ASI NO. 18

TO : Conventional Builders
FROM : Studio JAED
DATE : May 17, 2019
PROJECT : DeIDOT Phase II Renovations

PROJECT: STATE OF DELAWARE
 DELAWARE DEPARTMENT OF TRANSPORTATION
 OMB/DFM PROJECT # MC5511000018
PHASE II RENOVATION AND OCR COMPLIANCE PROJECT
 AT
 KENT COUNTY ADMINISTRATION BUILDING
 800 BAY ROAD DOVER, DELAWARE 19901

PARTIAL SOUTH LOBBY COMMONS PLAN - NEW WINDOWS

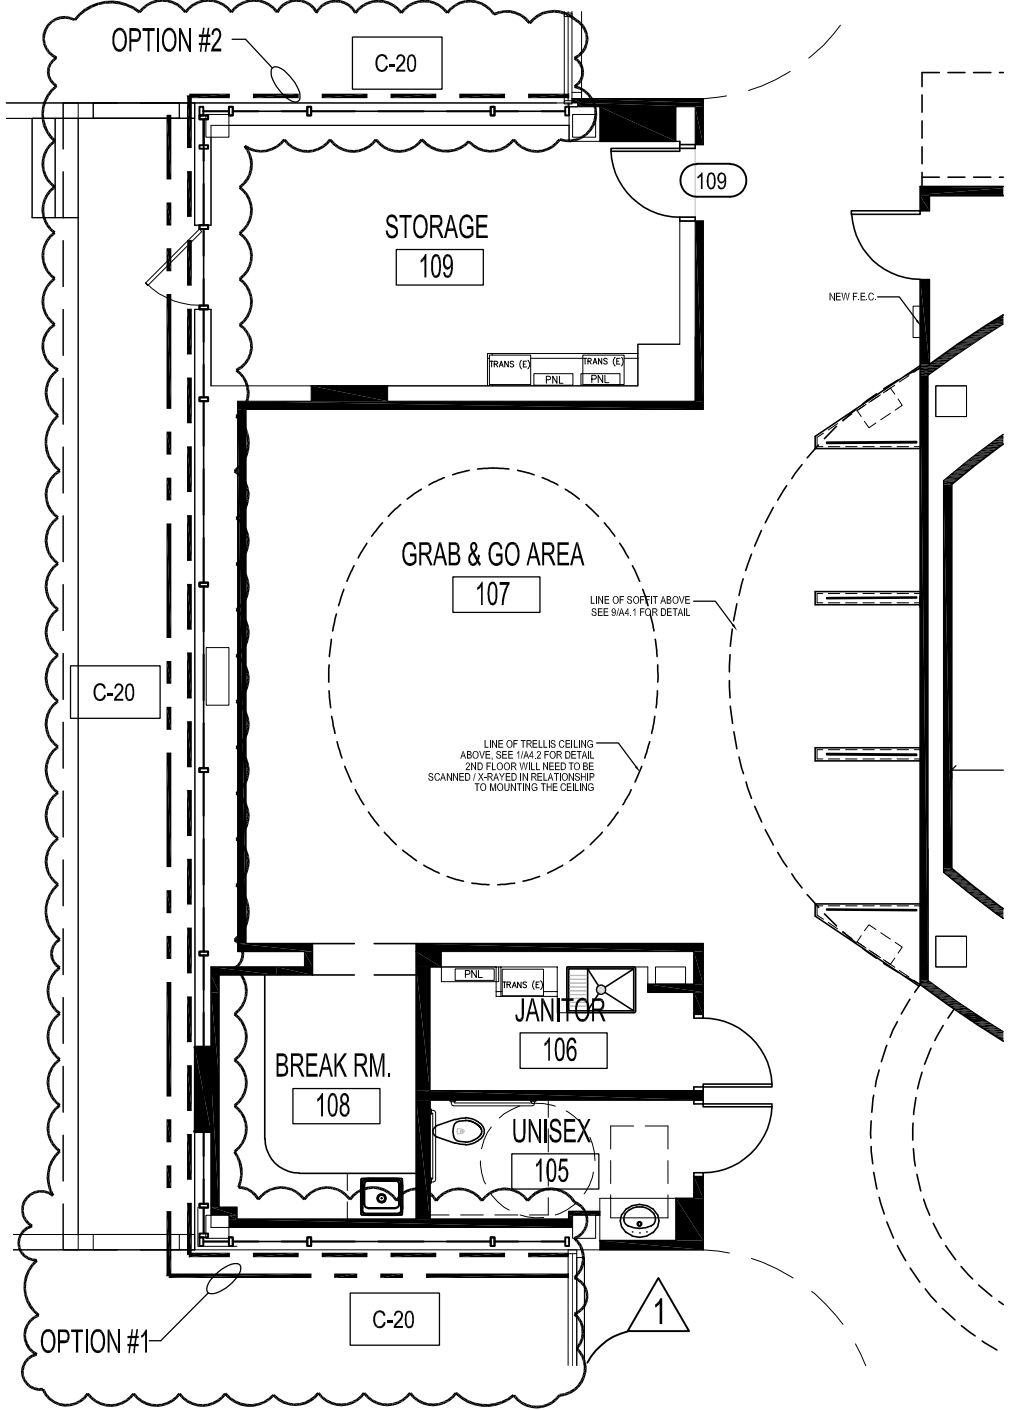
Proposal No. 1 – Provide cost proposal to perform work to remove and replace the windows on the exterior walls at the Break Rm, Grab and Go Area and Storage Room. Front and Side face of building. See SKA-.11 Option #1 designation for extent of work.

Proposal No. 2 – Provide cost proposal to perform work to remove and replace the windows on the exterior walls at the Break Rm, Grab and Go Area and Storage Room. Front, Side, and Rear face of building. See SKA-.11 Option #2 designation for extent of work.

1. Drawing A3.0 – See attached, Sketch SKA-.11.
 - a. Remove and replace windows in area shown.

C-20 REMOVE AND REPLACE EXISTING WINDOWS AT AREAS SHOWN. WINDOWS TO MATCH THERMALLY BROKEN TYPE BEING INSTALLED AT STAIR TOWER STORE FRONTS. FRAME TYPE AND FINISH COLOR (SILVER) TO ALSO MATCH WINDOW FRAMES IN AREA NOTED ABOVE.
